SAFETY EVALUATION REPORT
RELATED TO THE TOPICAL SAFETY ANALYSIS REPORT
FOR THE NAC STORAGE/TRANSPORT CASK, REVISION 2,
SUBMITTED BY NUCLEAR ASSURANCE CORPORATION

U.S. Nuclear Regulatory Commission

March 1988

FIGURE 2-1: SPENT FUEL CLAD MAXIMUM TEMPERATURE VS DECAY TIME (NAC S/T)

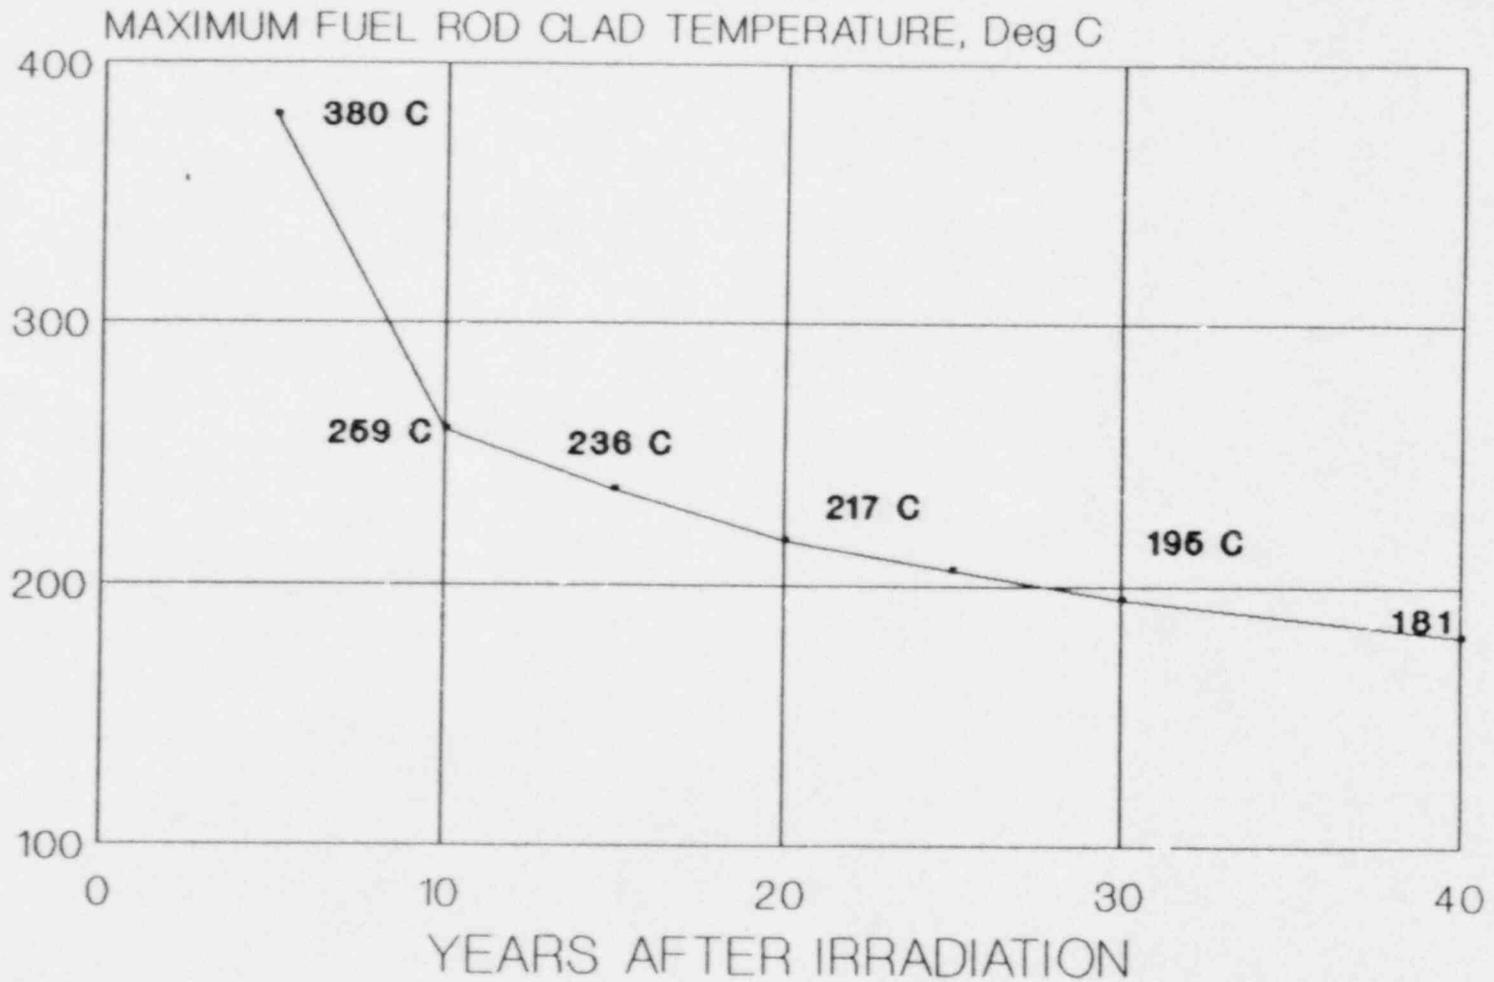
The temperature dependence of grain boundary decohesion was established using the temperature decay curve provided in Figure 4.8-27 of the TSAR. These temperatures were adjusted upward by 20°C for use in this analysis in the SER, because of the review of the thermal analysis discussed in Section 4.1.4 of this TSAR. See Figure 2-1.
